Final Environmental Impact Statement (FEIS)

BRITAIN WOODS
RESIDENTIAL DEVELOPMENT

Little Britain Road
City/Town of Newburgh, Orange, New York
SEQRA Type 1 Action

DATE: 02/10/26
JOB # 1146.01
SCALE: NTS
SHEET # 3.1D

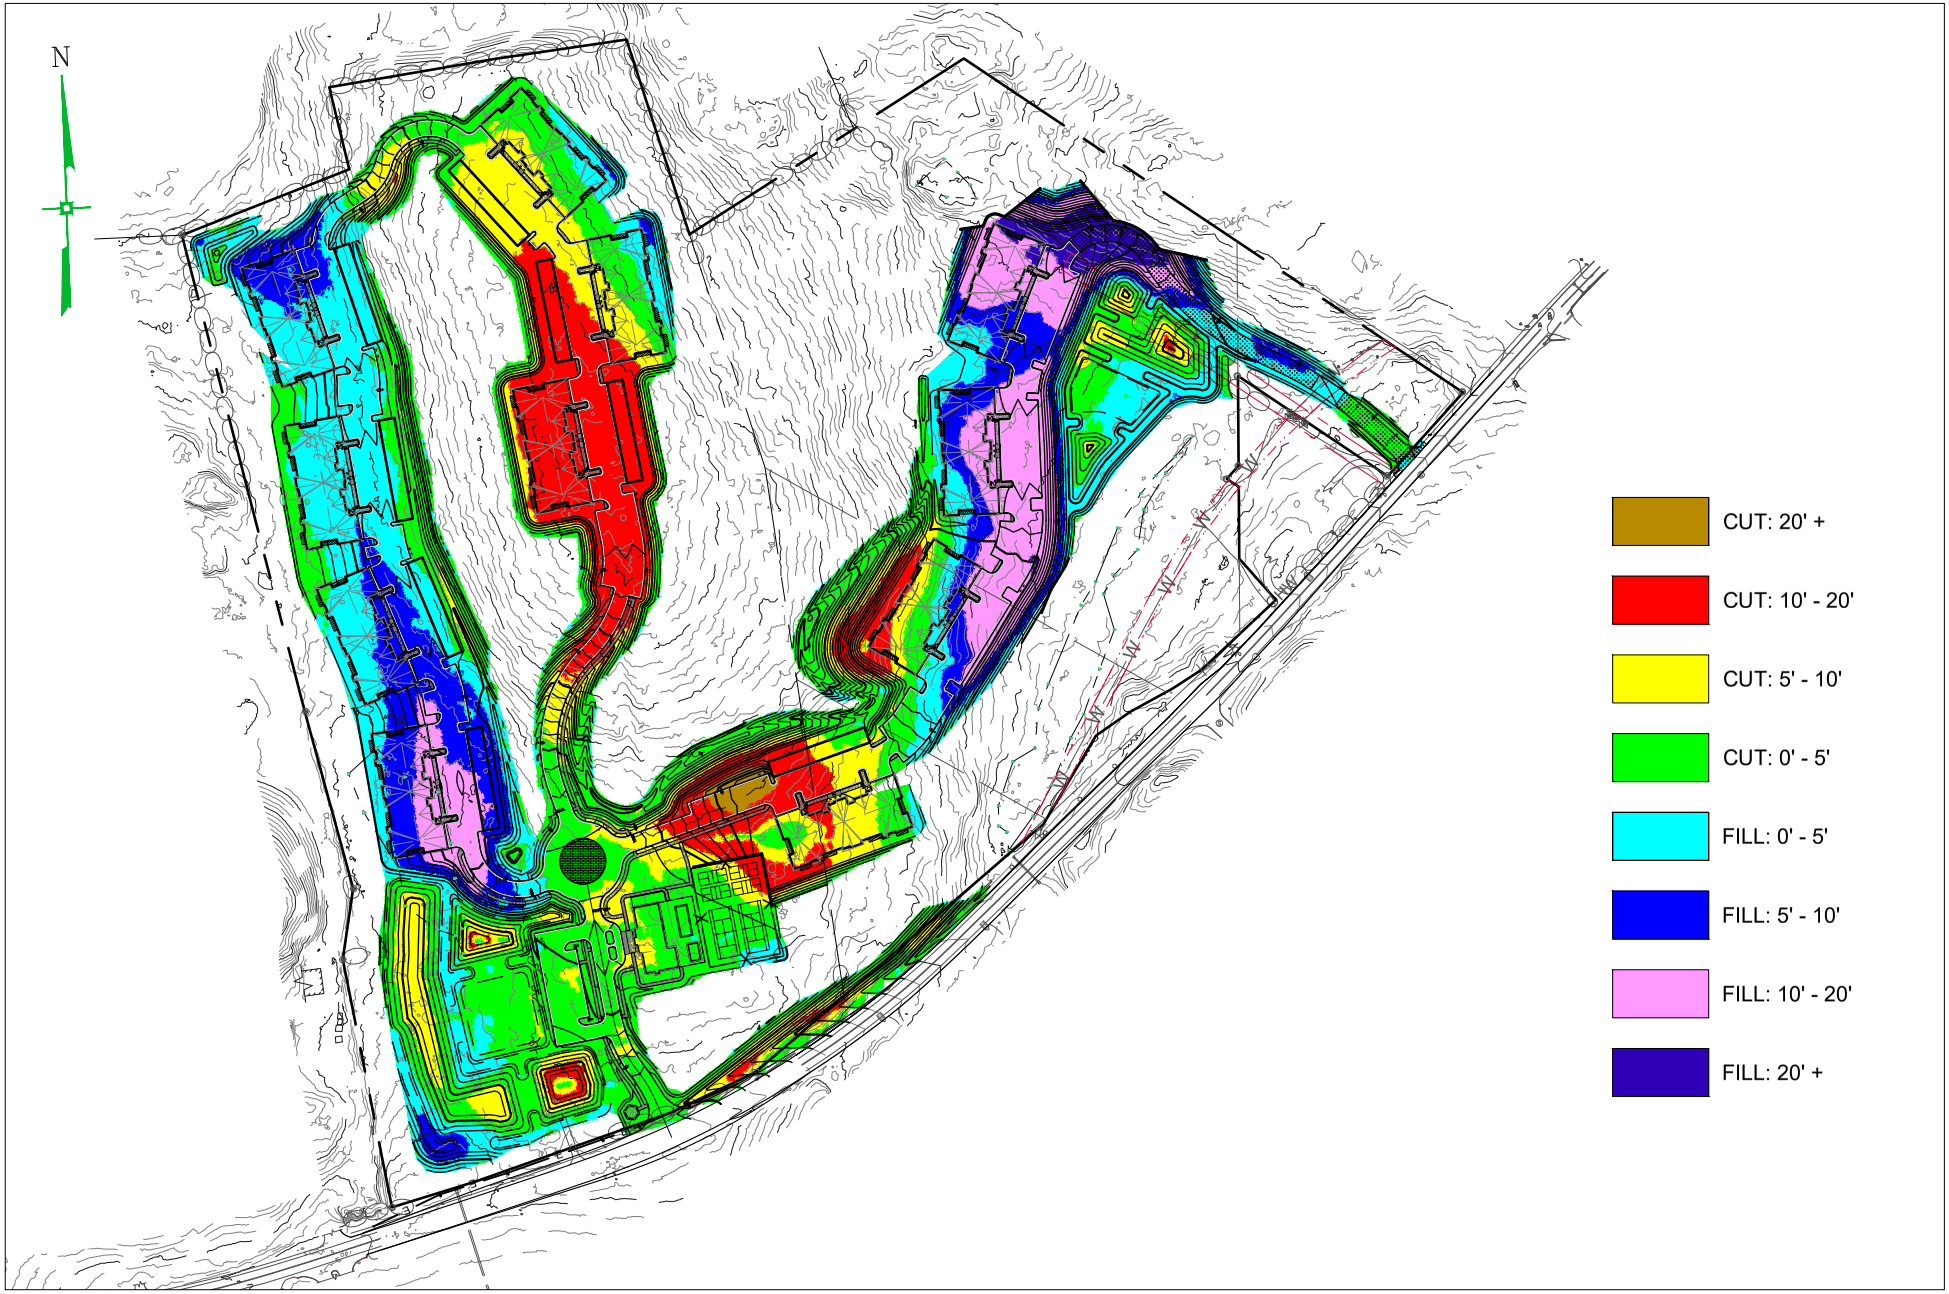
The project has a Figure 3.1E identifying general cuts and fill depths. Cut and fill depths should be identified on Figure 3.1B, which would provide the ability to determine impacts regarding depth to bedrock. Adding a column to the figure identifying finish grades and foundation depths in the area of these test pits will provide an evaluation of potential rock impact. A discussion regarding proposed foundations and utilities which will be below proposed grade should also be provided with appropriate analysis as to potential impacts for rock to be encountered.

As noted, cut and fill depths are shown on Figure 3.1E. The Test pit depth shown on Figure 3.1D matches the depth of required cut at each of the locations tested and identifies if rock or ground water was encountered. The site layout has been added to Figure 3.1C to show the location of the test pits in relation to the improvements. All foundations are slab on grade.

SHEET # 3.6B

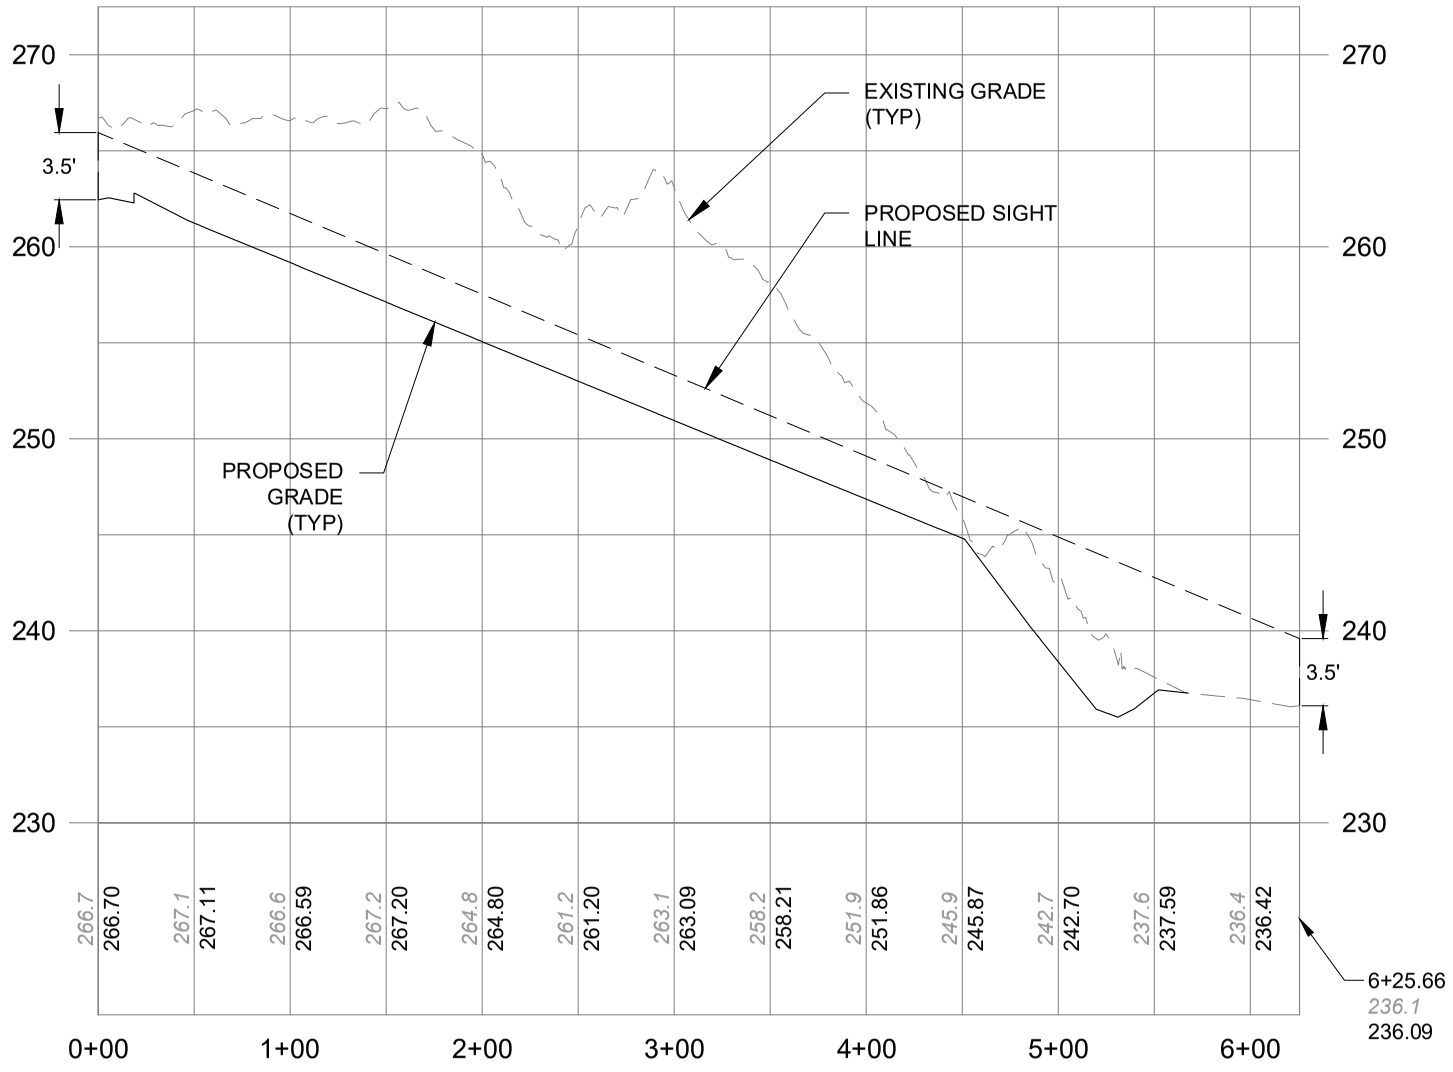
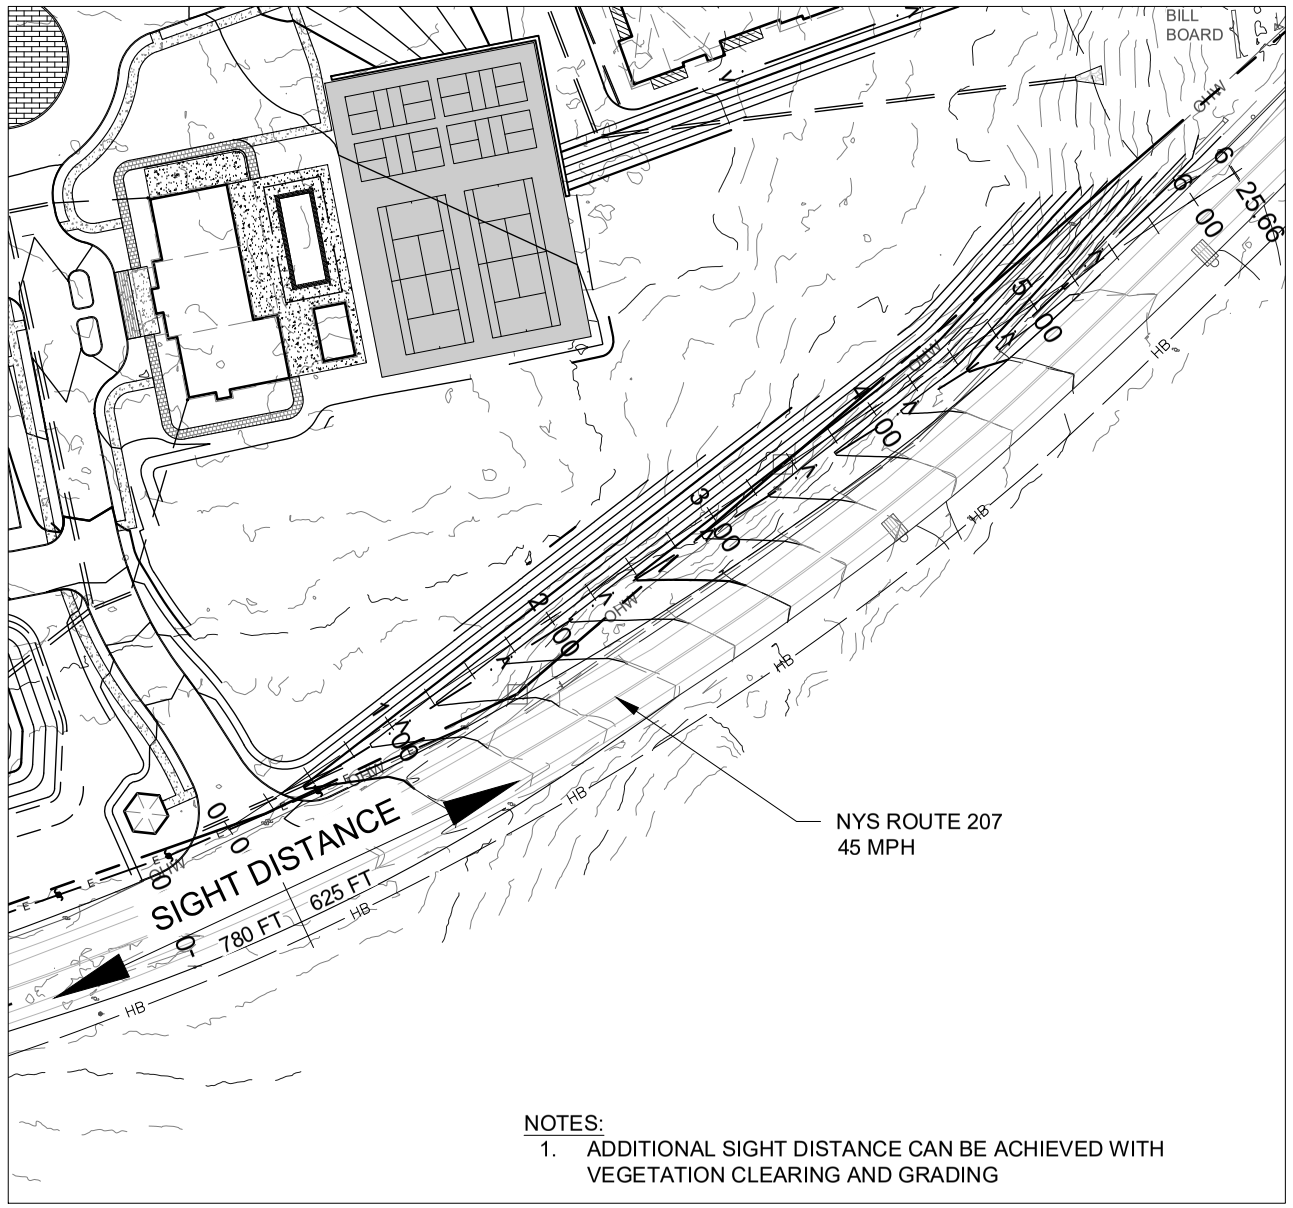
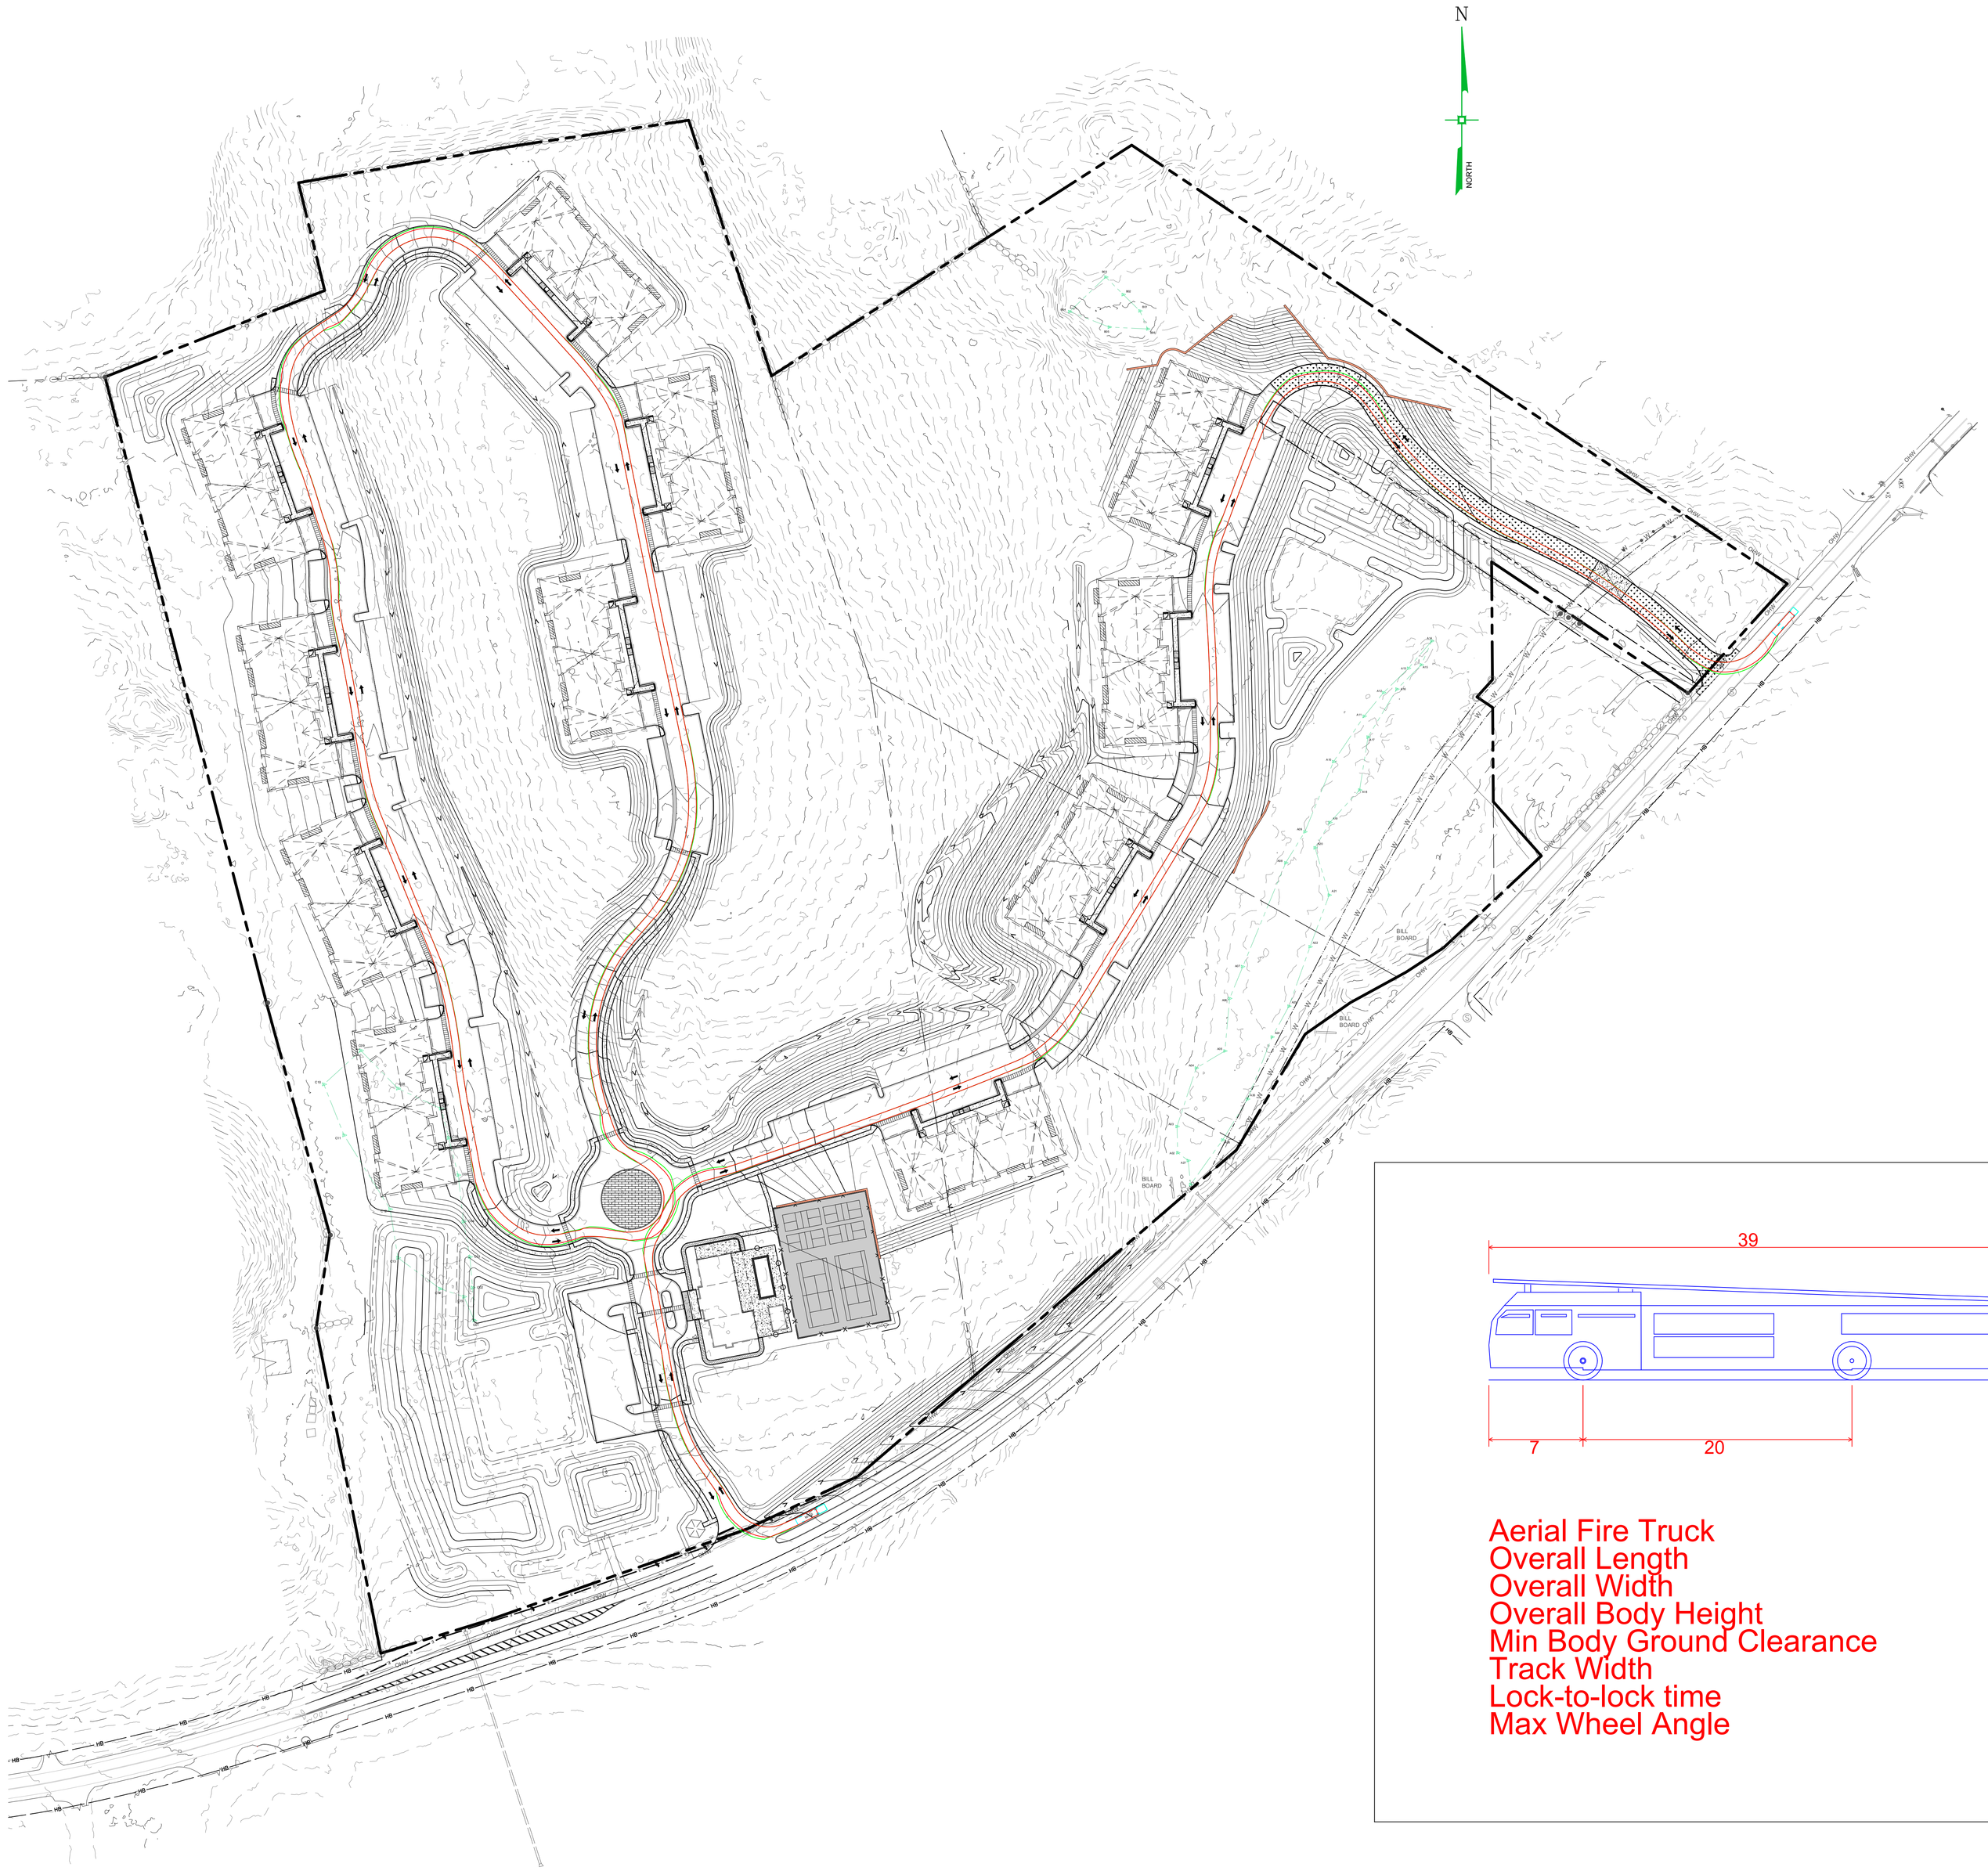
Comment 4.3.70 - Unsigned & undated "Aug Hearing Talking Points":
Page 81 of minutes (Dec), did Ross incorporate the sight distances that Wersted asked for? Check page 74/75 and Figure 3.6B

Section 3.6.2 Sight Distance – Appendix F7 provides a sight distance diagram and the DEIS provides figure 3.6B.

a. The sight distance looking to the right (west on Route 207) is approximately 780 and adequate for design speeds of over 60 mph – well above the posted speed limit (45 mph) and expected 85th percentile speed.
b. The sight distance looking left (east on Route 207) is estimated at 360 feet and looking across the inside of the horizontal curve of the road. Figure 3.6B indicates that the site has or will be graded back enough to not block this sight line and presumably vegetation will be maintained. For intersection sight distance, 360 feet is adequate for about 33 mph, well below the posted speed limit and presumed 85th percentile speed. It is adequate for the minimum stopping sight distance, which in our opinion would be applicable for a very low traffic generator, but not this project.
c. What is the 85th-percentile speed on the westbound approach of Route 207?

Response 4.3.70:
The sight distances for the Site Driveway have been updated in Figure 3.6B.

a. Comment Noted.
b. The location of the driveway has been reviewed by the Project Team and modifications have been made to provide the appropriate sight distance as shown in Figure 3.6B.
c. Based upon the ATR data, it is 47 MPH.
d. The location of the driveway has been shifted 50 feet to the east to improve sight distance.
e. The intersection sight distance looking straight for a vehicle to turn left into the site is 625 and is adequate for the posted speed limit of 45 MPH.

h. The text of the TIS was included in Section 3.6 of the DEIS and the appendices were included as DEIS Appendix F.
i. A sight line plan was included in the appendices in DEIS Appendix F7. An updated sight line plan is being provided with the Site Driveway modifications as Figure 3.6B.
